STAFF RECOMMENDATION

N. Witherell
NCPC File No. 7171

JUDICIARY SQUARE
H. CARL MOULTRIE I COURTHOUSE
Addition and Perimeter Security

October 28, 2010

Proposed C Street Elevation

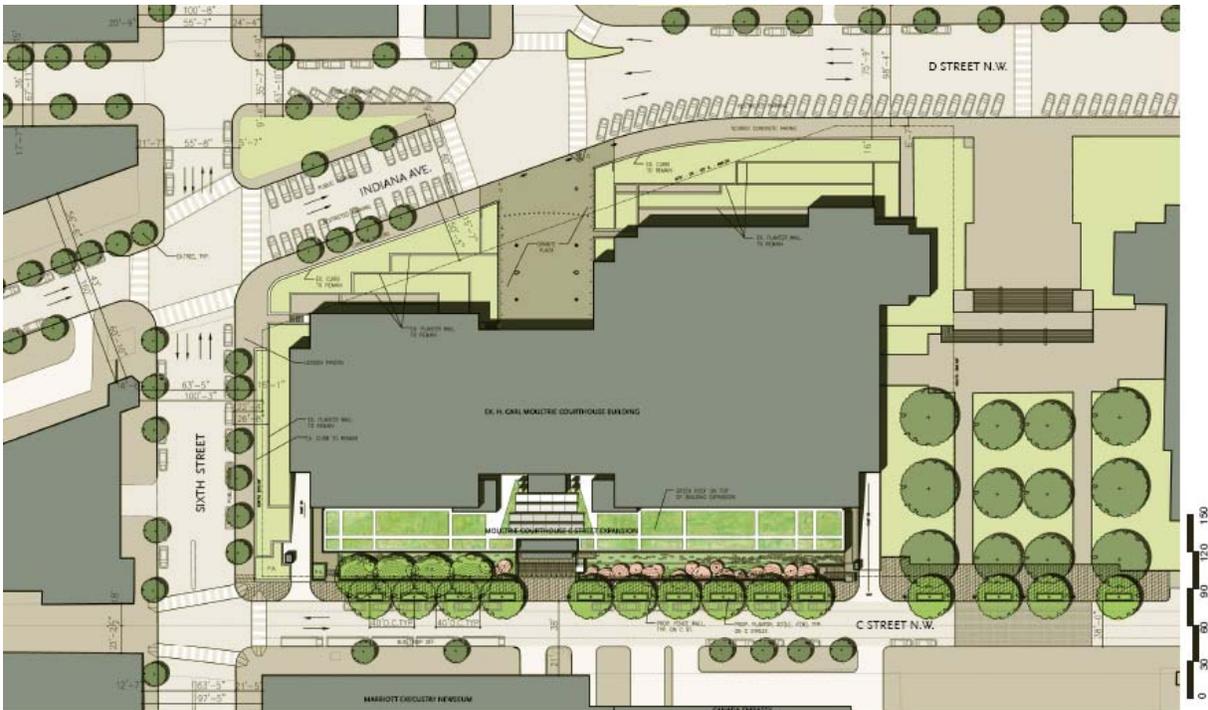
The concept design for the south façade expansion is primarily glazed, with limestone trim and will be developed further to add greater variation in scale and rhythm along C Street, NW.

The design approach of the courthouse expansion is an appropriate response, in staff's view, to the need for improved functions within the courthouse. Staff's view is that while the architects are proposing a different vocabulary and palette for the building's addition, the change and contrast are welcome. The modulation of the new elements—with greater and lesser areas of glass on the sides and front of the revised facade—helps to blend the old and new and make the addition more compatible with both the courthouse and its ensemble in Judiciary Square. Further modulation of the massing and a greater effort to incorporate elements and massing responsive to the pedestrian scale would be desirable; the DC Courts intends to incorporate these improvements during further development of the concept.

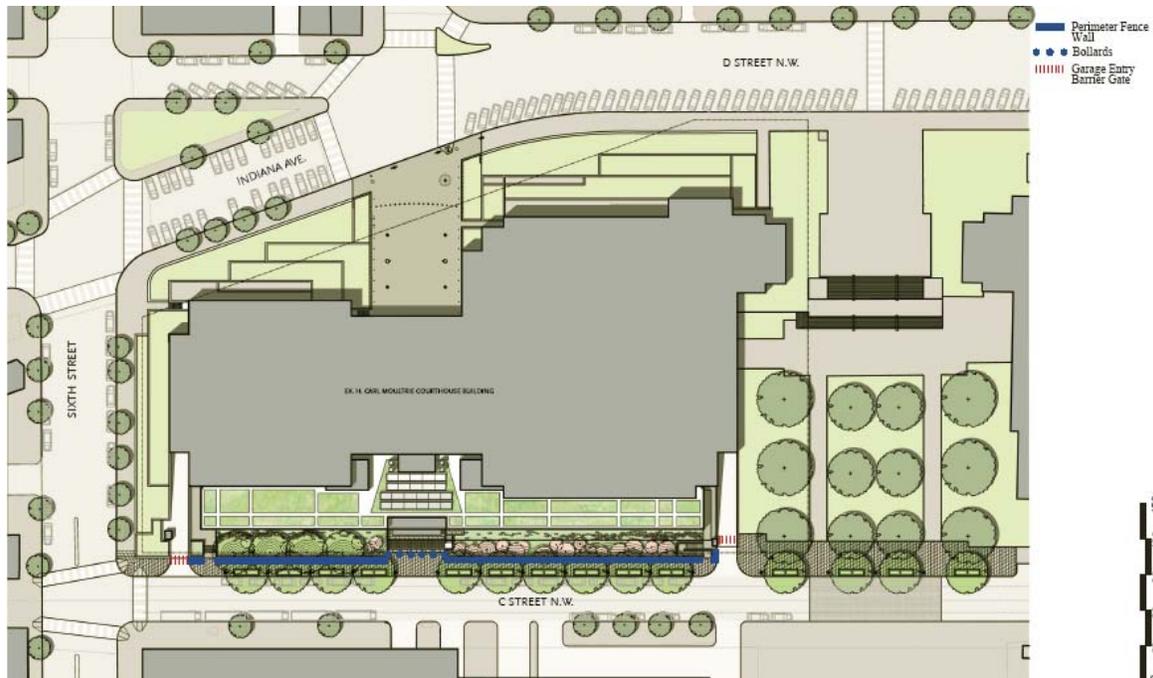
In the 2005 Judiciary Square Master Plan, the proposed security barrier line was located at the outside edge of the sidewalk, at or near the curb. In the current concept design submission, the barrier line is inside the sidewalk. This improvement is achieved through the proposed reconstruction of the original 38-foot cartway width, which provides an additional 12 feet of public space for the construction of a sidewalk and street tree boxes as well as the fence-wall vehicle barrier.

At the inside edge of the sidewalk, a 42-inch-high fence-wall serving as the vehicle barrier would be constructed at the sidewalk level. Inside of the fence wall, the 20-foot wide green garden described above would provide a green edge for the building, mediate a noticeable change in grade, and provide a 20-foot stand-off distance between the vehicle barrier and the building entrance and façade.

Proposed Site Plan, indicating with the blue line the location of the barrier fence-wall, 5 feet to the south of the courthouse's property line, at the inside edge of the sidewalk. Retractable bollards (shown in red) would be installed at both garage entrances.

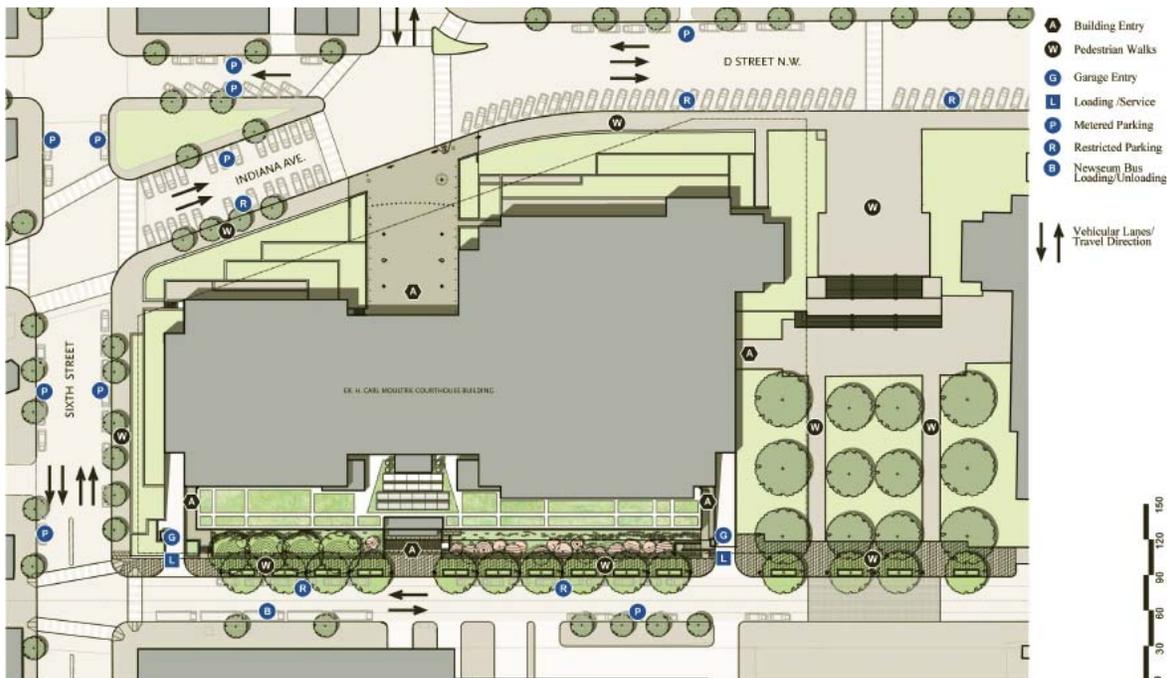
A feature of the concept design is the proposed restoration of the C Street cartway to 38 feet, a width documented on Baist Atlas Maps for C Street prior to the development of Judiciary Square and the construction of the Courthouse. This would narrow the cartway from its current dimension of 50 feet. The cartway was widened and expanded northward around the time the Moultrie Courthouse was constructed in the early 1970s. This caused the center line of the cartway to shift northward in front of the courthouse. By restoring the cartway to its original 38-foot width and the C Street right-of-way to its original 80-foot dimension and centerline, the DC Courts would realign the western portion of the block with the eastern portion of C Street, NW. C Street, NW in this part of the city is a short, three-block segment that dead-ends at the U.S. Department of Labor on the east and 6th Street on the west.

Given what the District of Columbia Department of Transportation (DDOT) has determined is limited through traffic on this segment of C Street, NW, DDOT is interested in the proposal to narrow the cartway to improve pedestrian safety. This is also a goal of the DC Courts and its Judiciary Square Master Plan. The restoration of the narrowed cartway and the location of its north curb and sidewalk is the action that would provide sufficient area for the barrier line to be located inside the sidewalk edge while still allowing a 20-foot stand-off zone for the courthouse.

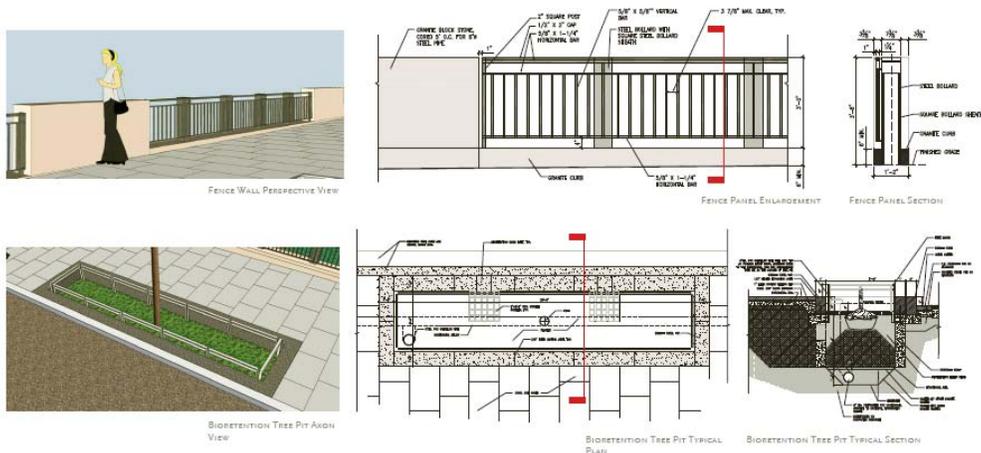
This is a marked improvement on the approved barrier location at the curb in the 2005 Master Plan and will result in a vehicle barrier that becomes part of the architecture of the building rather than a stand-alone feature near the curb. The DC Courts intends to submit a request for a Master Plan modification to document and analyze the restoration and realignment of C Street with the next project phase.
